Internal Parking Area & Drainage

Lancashire Highways (Pre-App) Advice:

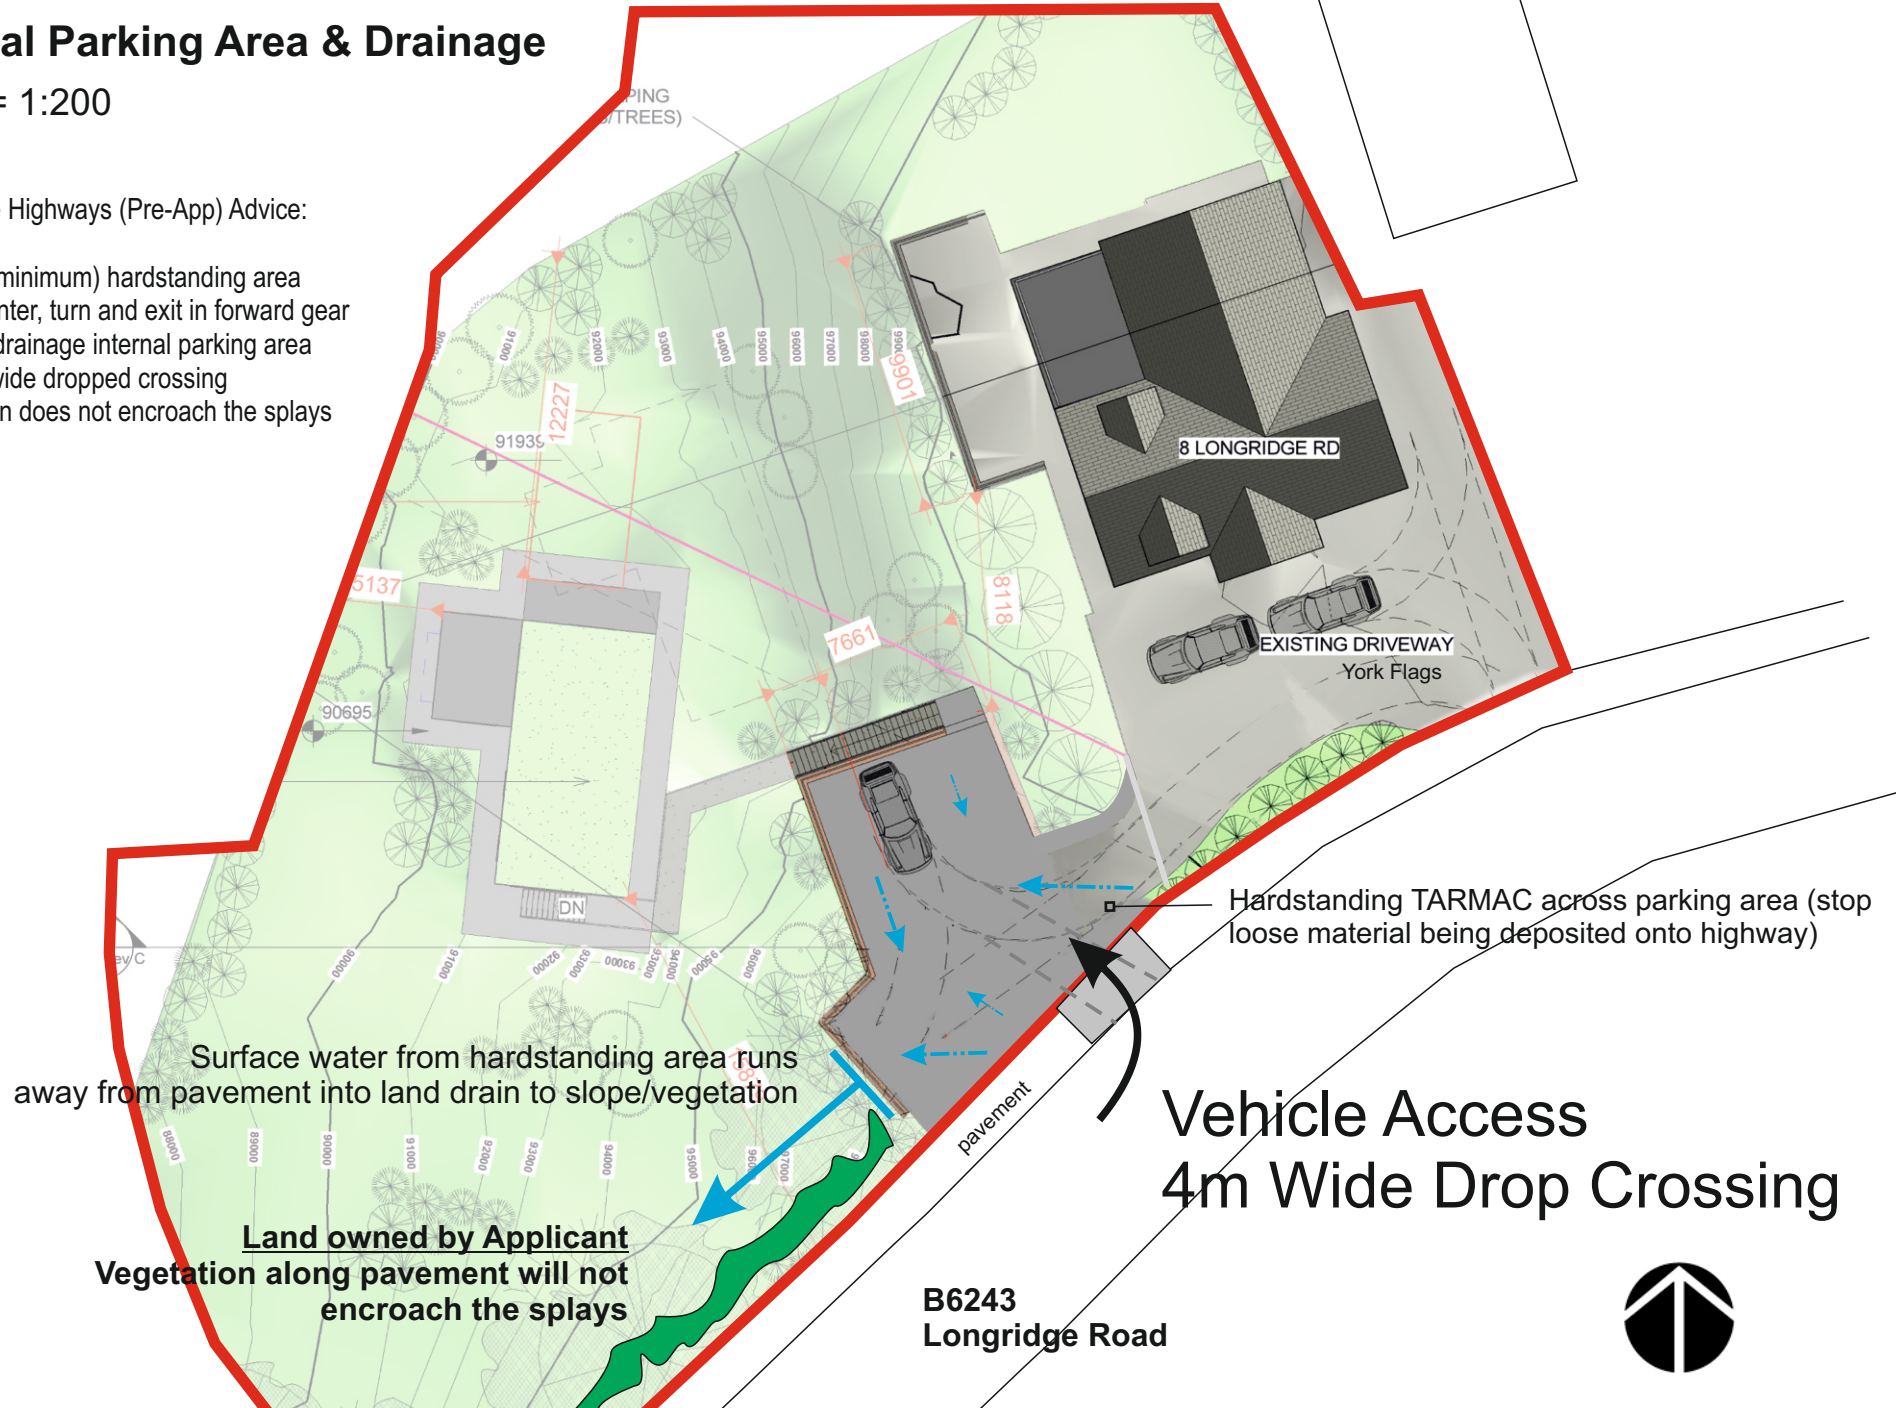
- 5 metre (minimum) hardstanding area
- Vehicle enter, turn and exit in forward gear
- Suitable drainage internal parking area
- 4 metre wide dropped crossing
- Vegetation does not encroach the splays

Hardstanding TARMAC across parking area (stop loose material being deposited onto highway)

Surface water from hardstanding area runs away from pavement into land drain to slope/vegetation

Land owned by Applicant
Vegetation along pavement will not encroach the splays

Vehicle Access
4m Wide Drop Crossing
